**DOLLAR TREE**  
 Energy Management  
 Plan

Interface Panel  
 & XCM Wiring Details

**SHORCORE**  
 APPROVED AS NOTED  
 REVIS AND RESUBMIT  
 REJECTED

⑤ REMOTE LCD DISPLAY (AS REQUIRED)

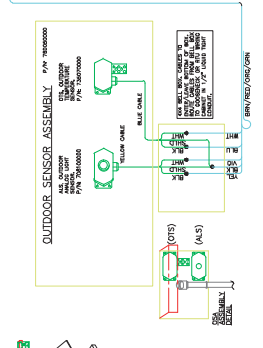
REMOTE LED DISPLAY  
 LOCATED IN MANAGER OFFICE  
 CONTROL THE CABLES BEING USED  
 INITIAL "4" W/ "4"
